ATTACHMENT I

Marked-up Technical Specification Page:

SAFETY EVALUATION

Florida Power and Light proposes to change St. Lucie Unit 1 Technical Specification 5.3.1. The purpose of this change is to permit the loading of fuel with a nominal active fuel length of between 134.1 and 136.7 inches. Fuel burnt in St. Lucie Unit 1 in cycles 1 through 7 has a nominal active fuel length of 136.7 inches. The slightly shorter active fuel length permits the use of a fuel rod design that is more resistant to fretting type failures than the present design.

FIGURE 1

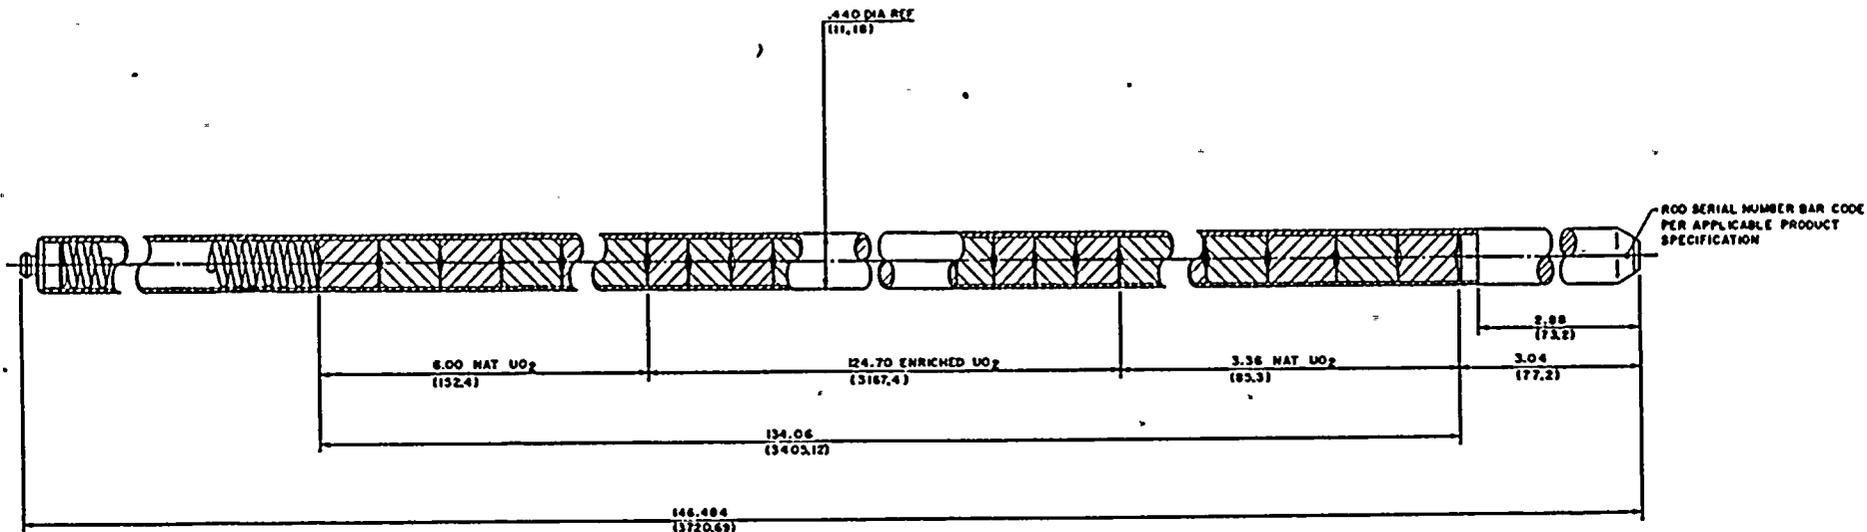
The nominal active fuel length of reload fuel will be reduced from 136.7 to 134.1 inches by removing approximately 2.64 inches of natural uranium from the lower axial blanket. This removal of material reduces the lower axial blanket length from 6.0 inches to 3.36 inches (Figure 1). In cycle 8 the shortening of the axial blanket in the reload fuel will result in a total reduction in the core's active fuel length of approximately 3250. feet, or 0.75%. The impact of this design change on the core power peaking and on the mechanical compatibility of reload fuel has been carefully evaluated by FPL. Results indicate that the proposed design change will have a negligible effect on the safe operation of the plant. These results are discussed below.

The proposed new dimensions of the lower end cap and zircaloy cladding were selected using two criteria. The first criteria was to minimize the length of axial blanket material removed from the pellet column. The second criteria was to position the cladding end cap weld above the contact point of the lower grid spring (given that the inter-grid spacing not be changed).

The dimensions selected ensure that the lower grid spring will contact the solid end cap, whereas previously the lower grid spring contacted the cladding. This positioning of the contact point on the solid end cap should also help eliminate lower grid spring fretting as a potential failure mechanism.

A slightly shorter active fuel length permits the use of a longer solid zircaloy end cap while retaining the same overall fuel rod length and assembly length and configuration. The longer end cap, which will be lengthened from 0.4 inches to 3.04 inches, will extend approximately half way up through the lower spacer grid assembly at which point it is welded in a standard fashion to the fuel rod cladding.
